ZONING CHANGE REVIEW SHEET

CASE: C814-06-0233 – Wildflower Commons
Planned Unit Development

SUBJECT: Corrections to ERM's August 22, 2007 memo regarding Critical Environmental Feature setbacks of Wildflower Commons.

**Map 1: Location Map for Critical Environmental Feature Setbacks
(Revised - 07-07-2008)**

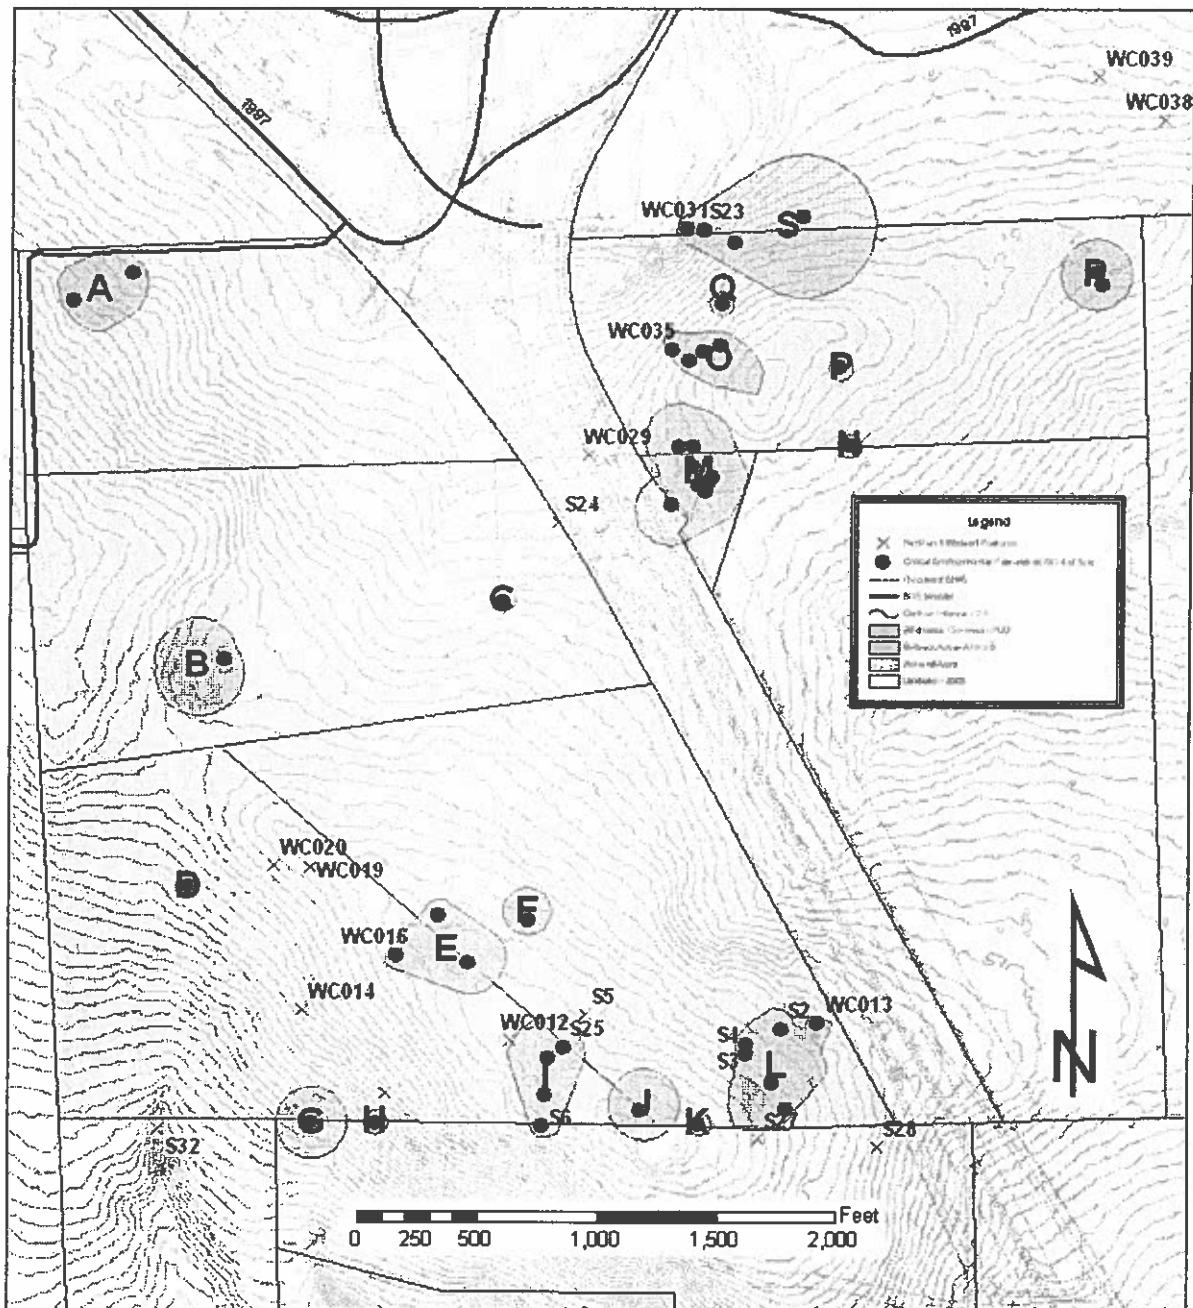
1. No residential lots may include a CEF or be located within 50 feet of a CEF.
2. Setback areas must be established to protect all CEFs. Although the LDC allows a portion of the CEF buffer to be included in a residential lot, I do not recommend that this be allowed. Residential lots should not include any portion of a CEF buffer. Setbacks must comply with the setback area has stated in Table 1 and shown Map 1. ERM is willing to revise setback areas listed in Table 1 and shown on Map 1 during PUD process, if the applicant provides more detail

2. All CEFs and associated CEF buffers are to be shown on all plats, preliminary plans, site plans and construction plans. The PUD ordinance and the plat notes must have a following statement "all activities within the critical environmental feature setback must comply with Section 25-8-281(c)(2) of Austin's Land Development Code. This section states that the natural vegetative cover must be retained to the maximum extent practicable; construction is prohibited; and wastewater disposal or irrigation is prohibited this requirement."

5. Fencing at the edge of CEF buffers must be installed prior to the initiation of construction.
6. Water quality BMPs should not drain directly into CEF setback area. Level spreaders or similar structures must be used to overland sheet flow stormwater before it discharges near CEF setback areas. Stormwater irrigation must occur outside the CEF setback areas.

7. An IPM plan should be prepared for Wildflower Commons PUD.
